IN THE MATTER OF THE MELBOURNE METRO RAIL PROJECT  
INQUIRY PURSUANT TO THE ENVIRONMENTAL EFFECTS ACT AND  
ADVISORY COMMITTEE PURSUANT TO THE PLANNING AND  
ENVIRONMENT ACT

**OUTLINE OF SUBMISSIONS ON BEHALF OF  
OWNERS CORPORATION 348427V ('THE BOTANICA')**

Figure A.35: Domain Station Precinct - Scenario A(i) - Predicted Noise Levels at 1.5 m above ground - construction activities to be undertaken during Normal Working Hours

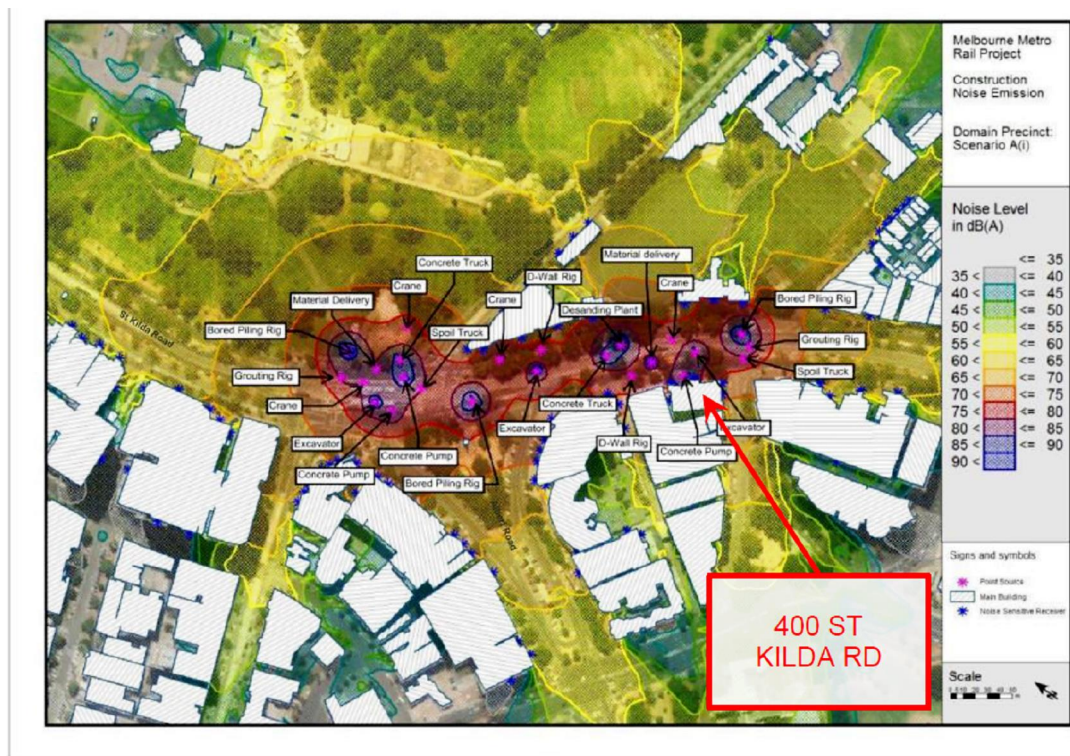
- c. Lack of clarification of the duration that daytime noise levels of a magnitude exceeding 80dB(A) would be present at the Botanica. Mr Goddard notes that Appendix A, Figure A.35 of the Noise and Vibration Technical Appendix includes predicted daytime construction noise levels indicating the St Kilda Rd façade of the Botanica will be exposed to levels above 80dB(A) (extract shown below).

As Mr Goddard identifies, ‘...anything above the first two levels will receive negligible attenuation from a 6m high barrier and be exposed to 80dB(A)+, which is very different to the 64dB(A) Leq during the day baseline level, not ‘marginally higher’.’<sup>5</sup>

He identifies that ‘Such high noise levels would have a significant impact on residents, so it is important that the expected duration of this stage is made

*clear in order to fully understand the magnitude of the impact and assist residents in making decisions regarding actions that may be taken.'*<sup>6</sup>
